Mr. Doug Anderson
ENERGY STAR Home Improvement Program
U.S. Environmental Protection Agency
1200 Pennsylvania Avenue, NW
Washington, DC 20460-0001

Subject: - ENERGY STAR Program Requirements for Residential Windows, Doors, and Skylights –
Version 6.0 Final Draft Eligibility Criteria

Figure 1: Scatter plot of EPA cost data, by U-factor (illustrative data only)

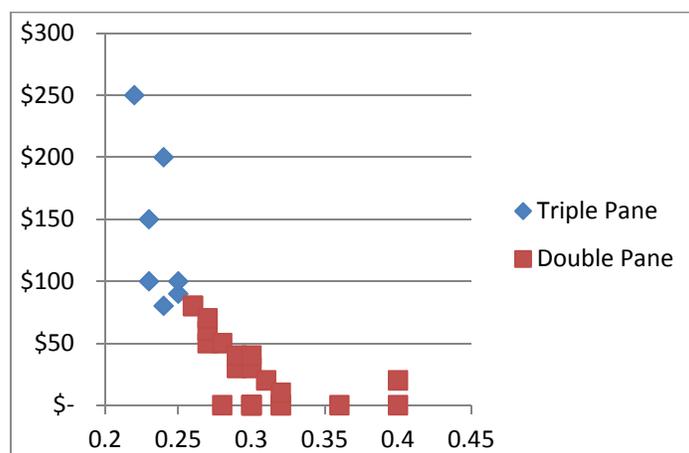
Information characterizing the cost data EPA received from manufacturers has also been withheld from the public, with EPA again citing the need for confidentiality. While we recognize that EPA needs to carefully ensure that confidential information is not compromised, we do not understand why EPA cannot develop an approach that respects both the confidentiality needs of the eight manufacturers, and the legitimate need of EPA's stakeholders. This information is critical to understanding the information on which EPA is basing its decisions and to the ability of stakeholders to assess the Agency's decisions. EPA should be able to release blinded data without causing competitive harm to the manufacturers. In our view, EPA could for example, make a simple scatter plot depicting the submitted cost data for each U-factor available to the public. An example of what we recommend is found in Figure 1, which was developed using the mock data EPA released with the Final Draft specification.

If EPA believes that this type of chart could compromise the confidentiality of cost data provided by specific manufacturers, they should explain why. Such transparency in the Agency's reasoning would serve as a basis for determining how this information could be appropriately shared with stakeholders.

Figure 7: EPA Version 6.0 Final and Industry Payback Comparison for Half-lite Doors (with consumer expected payback of seven years indicated with a red line)

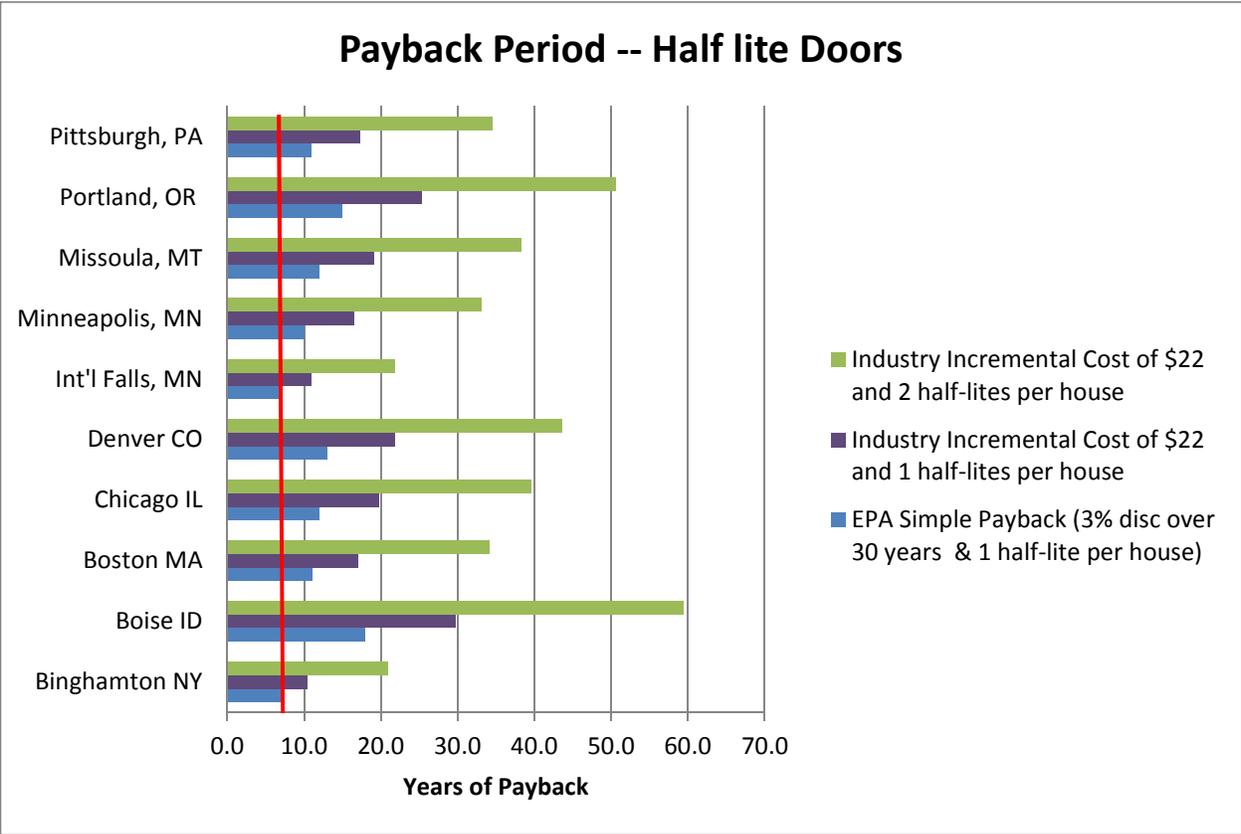
In addition, EPA indicates there will be minimal incremental cost for half-lite door changes, but analysis by door manufacturers indicates the cost is nearly double the EPA estimate. There should be no change to half-lite doors if there are no associated energy savings that provide a reasonable payback for consumers. For example in Boise, which is a heating dominated climate, the payback period is 18 years by EPA Version 6.0 final estimates, and 60 years by Industry estimates. With little exception, the estimated payback significantly exceeds what is acceptable to consumers in many regions of the country. Please see Figure 7 below which is based on a more reasonable seven year payback period that is demonstrably more acceptable to consumers as discussed in Section 2.3 of these comments regarding our concerns over the lengthy payback periods for windows.

As with windows, we also urge the Agency to redouble its efforts to explain its decisions on doors and reduce its reliance on conversations and data collection activities that occur outside of the public process. This is critical to better and more clearly justifying its decisions regarding the Final Draft door specifications. We further urge the Agency to revisit these decisions based on additional comments submitted by WDMA members in response to the Final Draft.
